# Memorandum

RE: 25 DUNHEVED CIRCUIT, ST MARYS RESPONSE TO SUBMISSIONS

On behalf of reDirect Recycling, The Transport Planning Partnership (TTPP) has prepared this memorandum to address Department of Planning's (DPIE's) traffic query as follows:

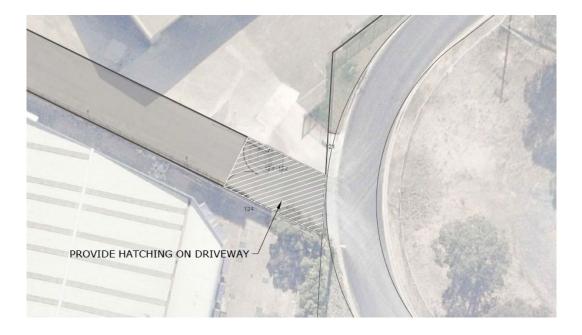
8. The Department notes that the swept path analysis (Appendix G of the RtS) shows that 19m articulated vehicles require the whole driveway width for the property when entering and exiting the site, and therefore only one vehicle could enter or exit the site at one time.

The "conflict area" is defined as the area where only one vehicle is able to travel at a time. In this case, the conflict area would be the length of the driveway and area in front of the driveway where the 19m semi-trailer swept path occurs which is measured as 25m (see below).

Based on 9 vehicle trips per direction during the operational peak hour, the probability of a vehicle arriving when another vehicle is within the conflict area is calculated to be 0.050% (1 in 2020 chance). Hence, there would be a very low probability of opposing vehicles meeting at the site access driveway.

Should such a conflict occur, the driver would need to wait for the driveway to be clear before proceeding. Under these conditions, the driver would wait up to 9 seconds for the opposing vehicle to clear the driveway.
